ADDENDUM NO. 3

GARRETT COLLEGE MULTIPURPOSE FIELD SITE PREP

Date of Issue: December 30, 2022

SPECS JOB NO. 5593

UTILITY TRENCH DETAIL: NON-PAVED AREAS 6
NOT TO SCALE

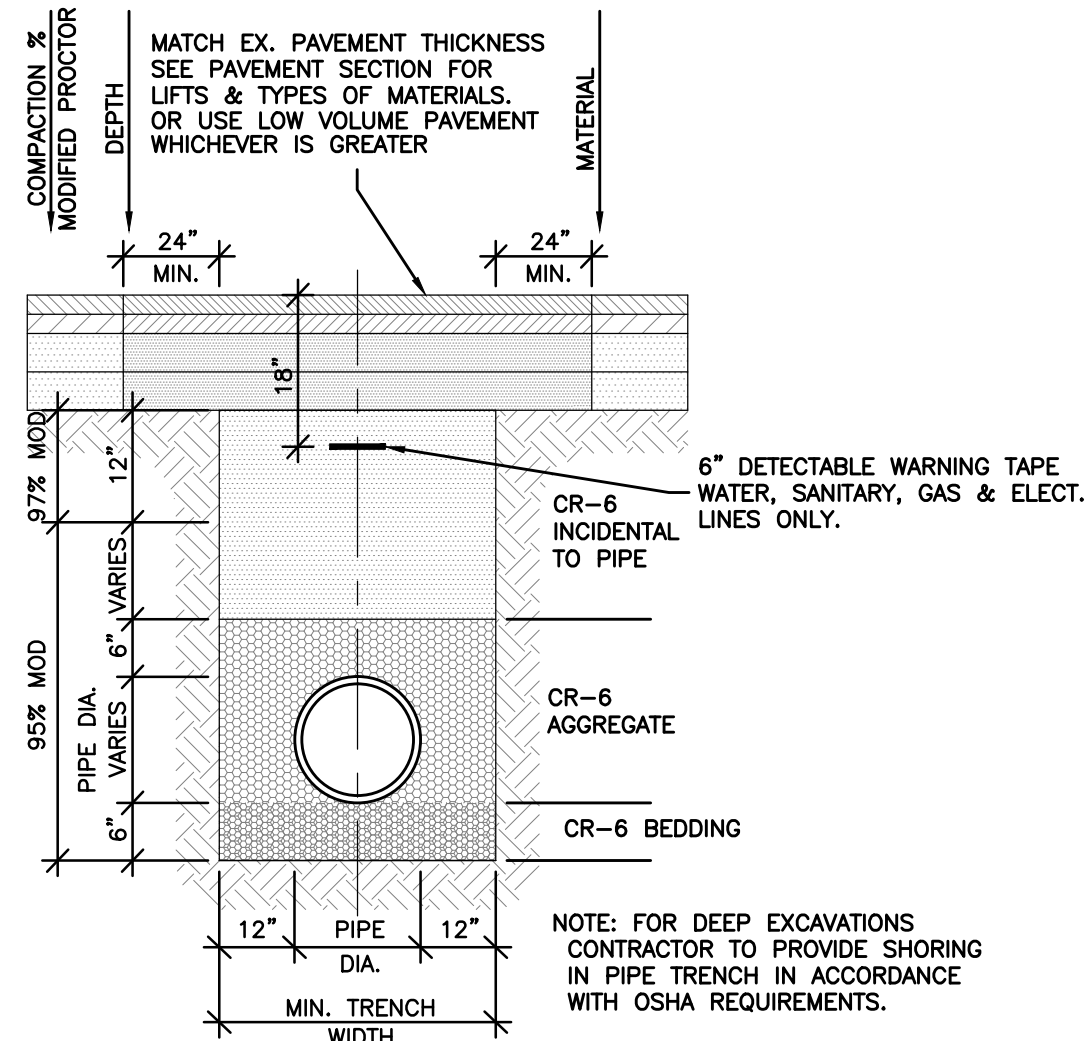
3. **REPLACE** Sheet C0.2 with revised sheet. Added invert in to Inlet I-14. Also revised detail 6 to reflect different French drain pipe sizes.
4. **REPLACE** Sheet C0.3 with revised sheet. Revised Detail 6.
5. **REPLACES** Sheet C2.0 with revised drawing. **CHANGE** diameter of French drain pipe from I-2 to I-1 from 8" to 12" HDPE. **ADD** 8" PERF UNDERDRAIN note for French drain pipe from I-2 to I-14.
6. **REPLACE** Sheet C4.0 with revised sheet. Sequence of Construction was revised.
7. **REPLACE** Sheet C4.1 with revised sheet. Sequence of Construction was revised.
8. **REPLACE** Sheet C5.2 with revised sheet including added profile between I-14 and I-2. Note pipe is deflected in the middle to drain both ways.

MULTIPURPOSE FIELD SITE WORK
GARRETT COLLEGE
MISCELLANEOUS CONSTRUCTION DETAILS

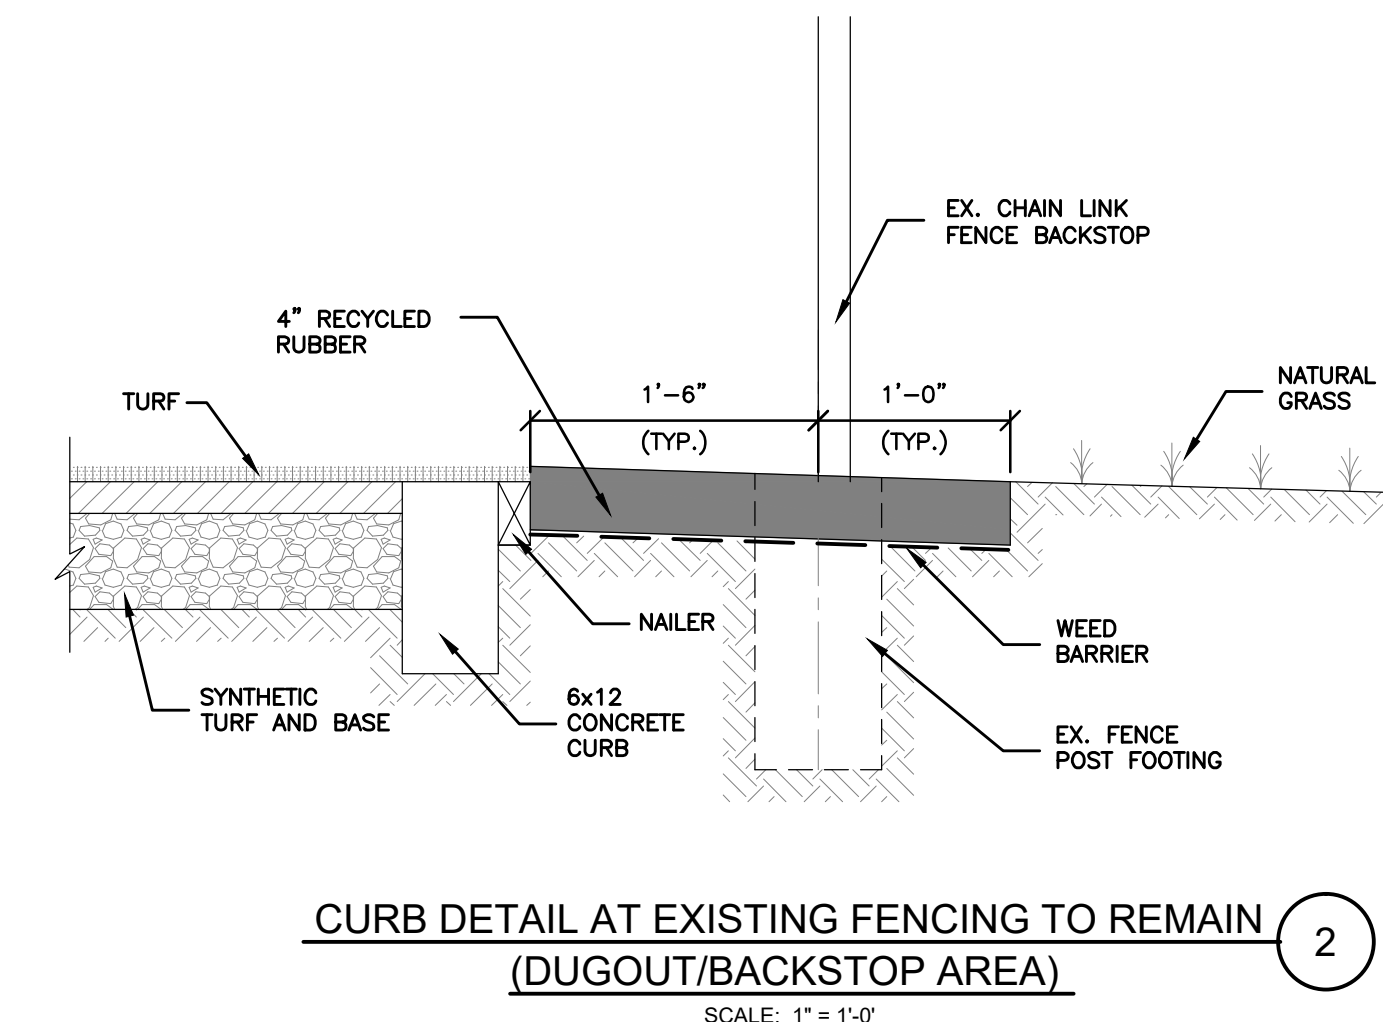
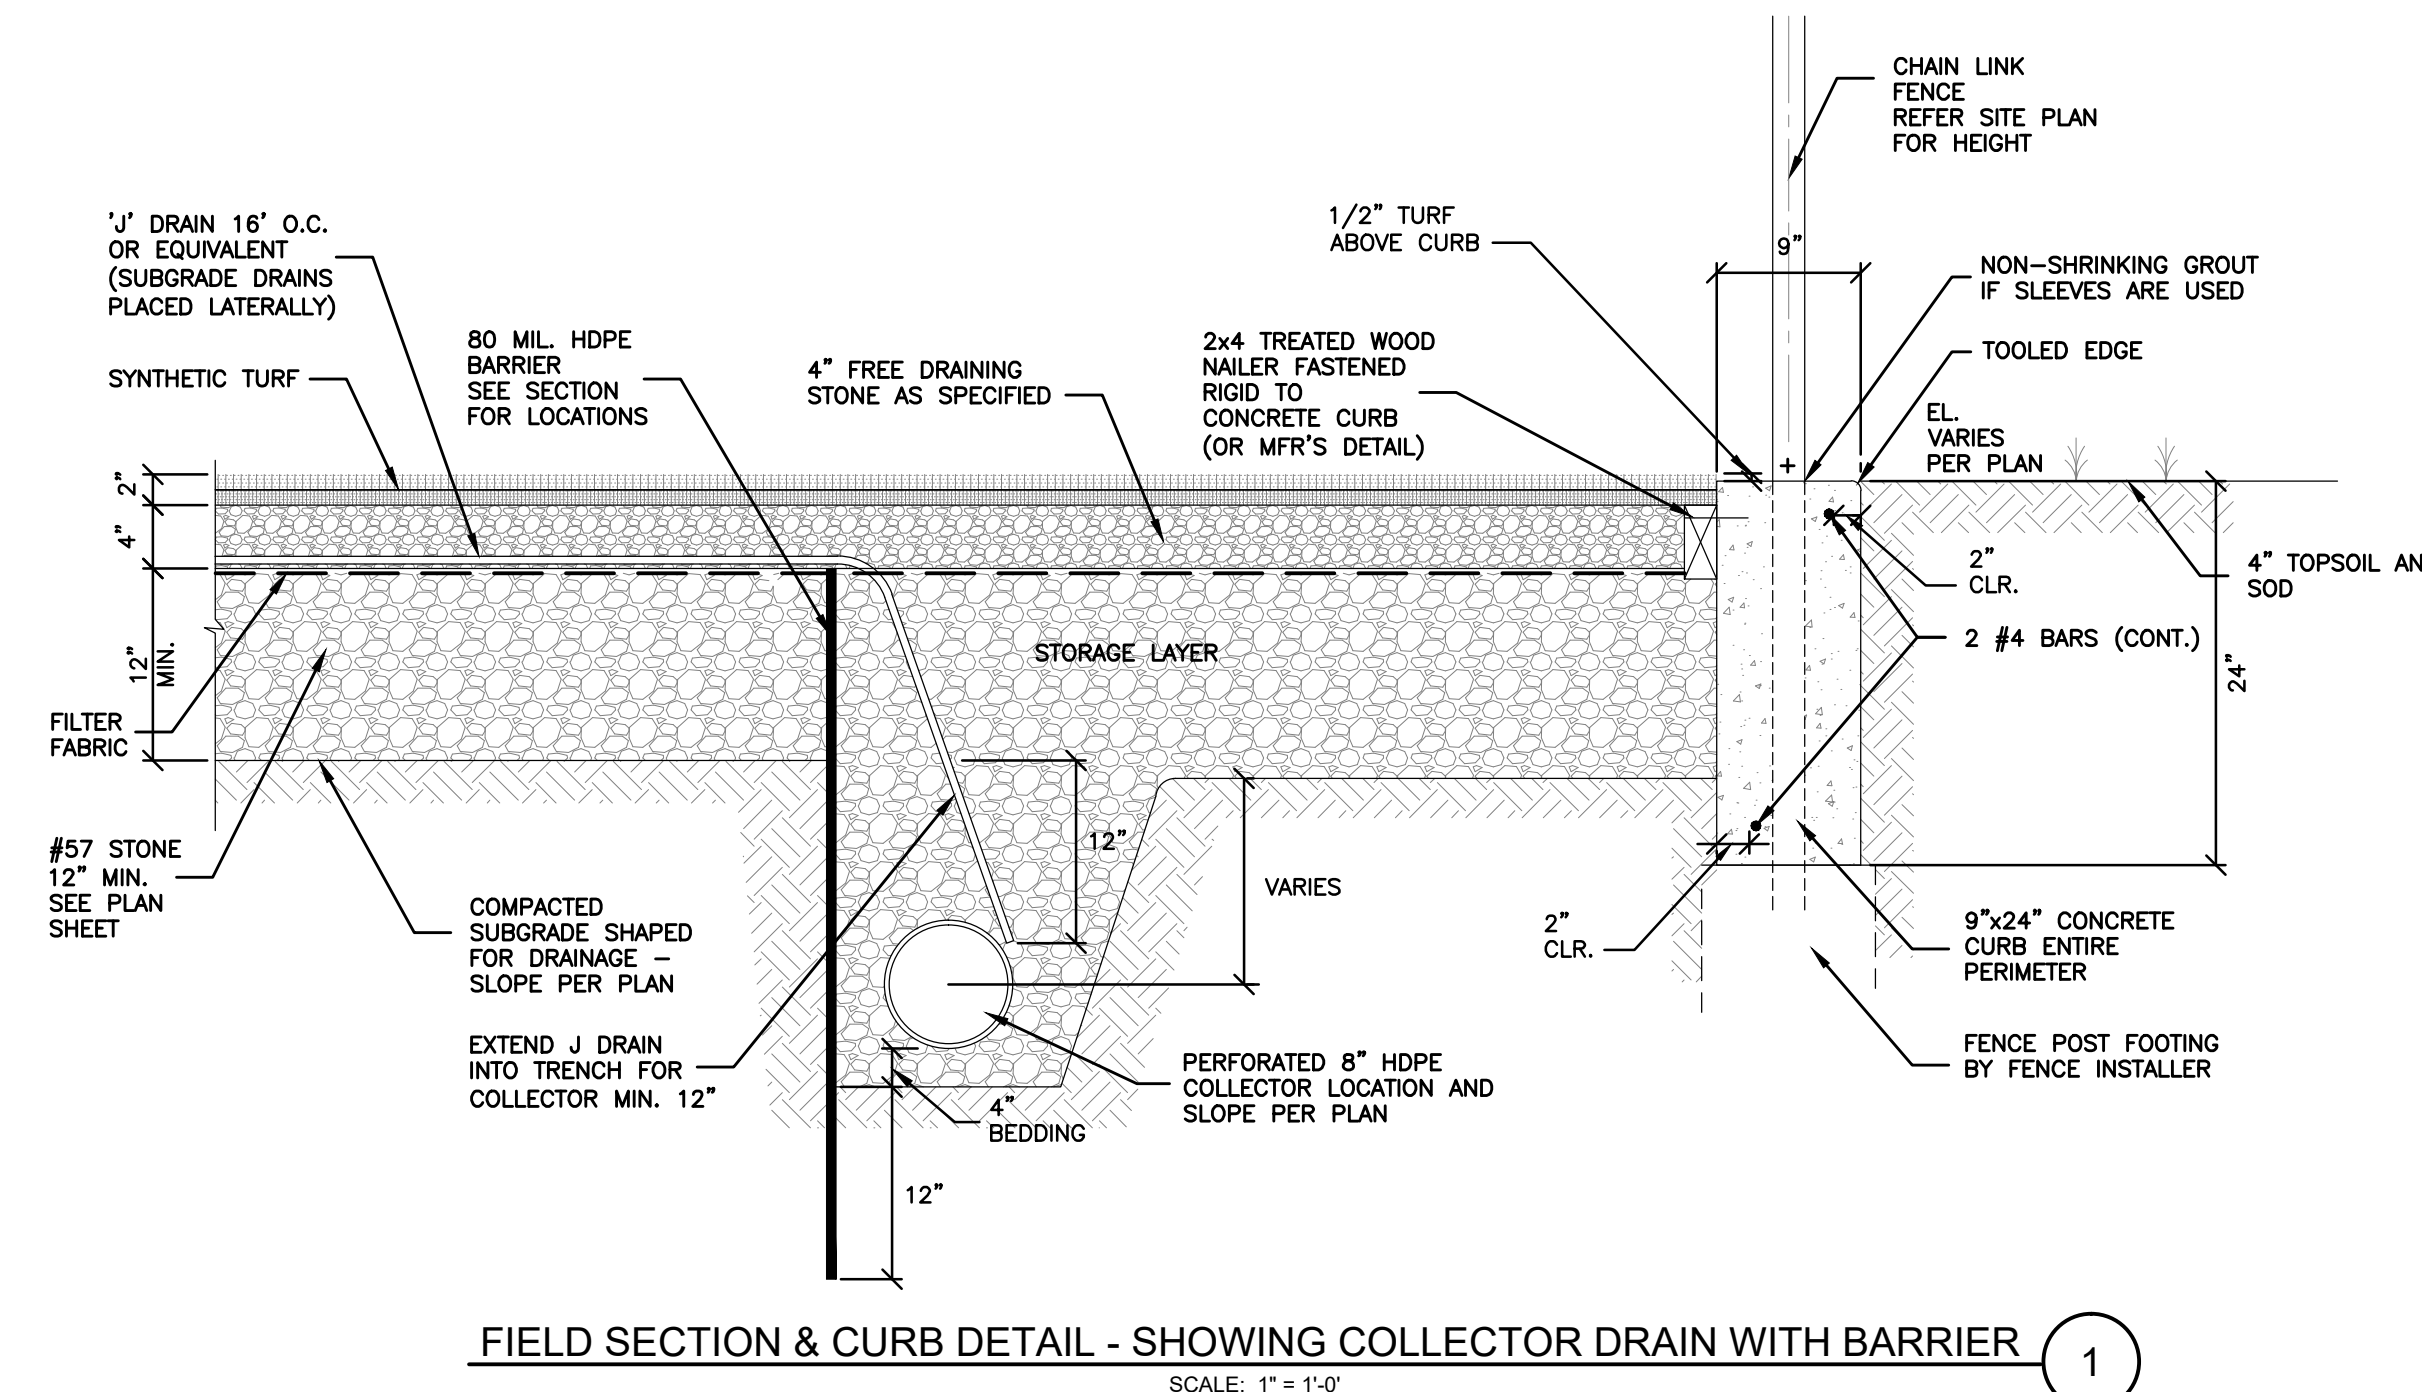
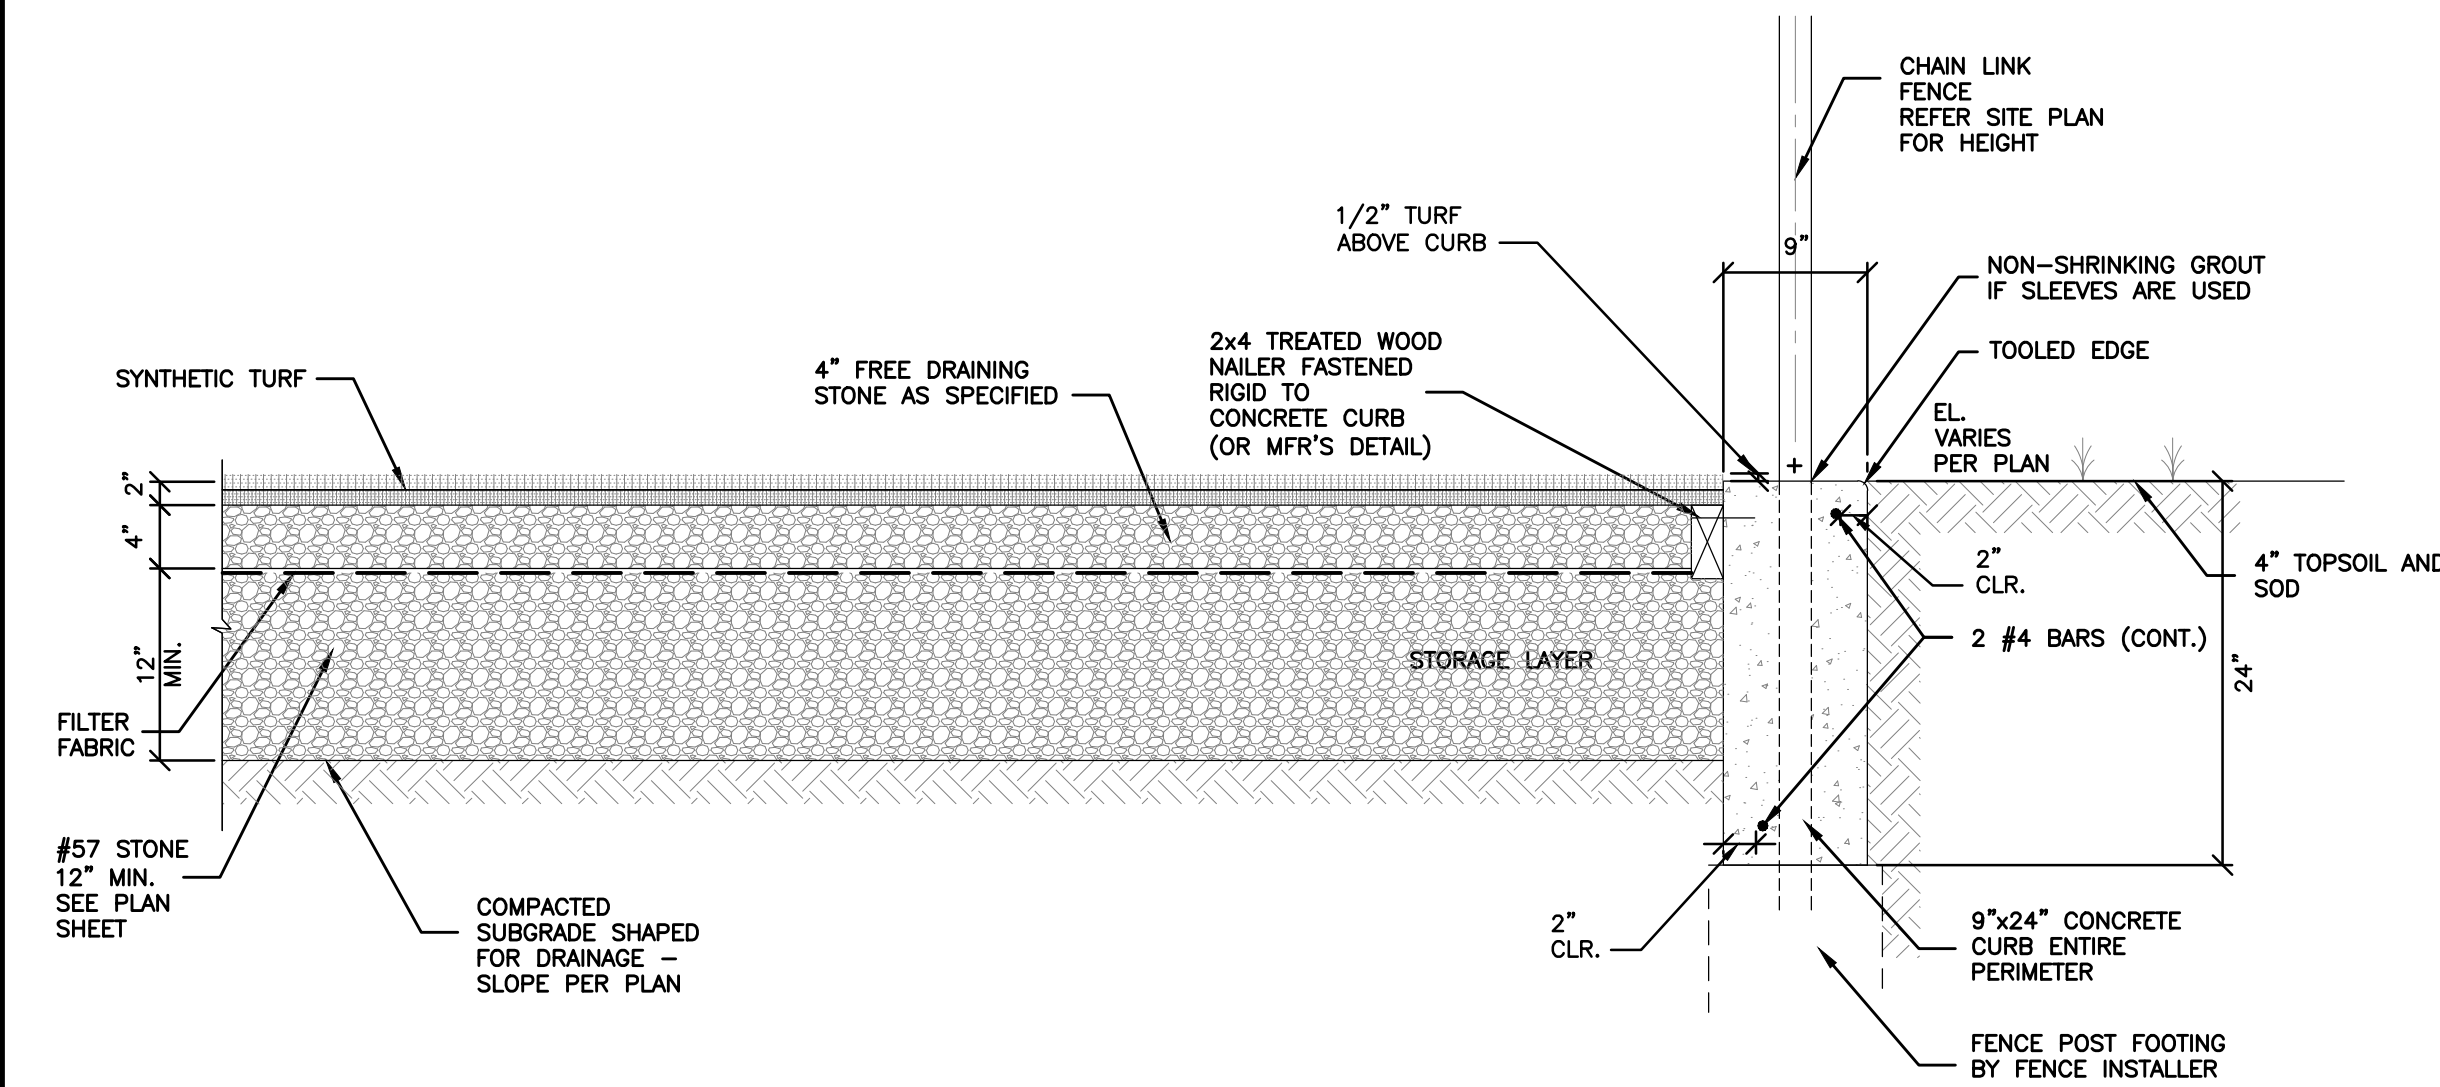
1. **REPLACE:** SHEET C0.0 with revised sheet. Change Table of contents and signature block. Drawings marked Revision 1.
2. **CLARIFICATION:** Detail 1/C0.3 and similar: Contractor may use sleeves for fence embedded in concrete. If sleeves are used, posts to be secured with non-shrink grout.
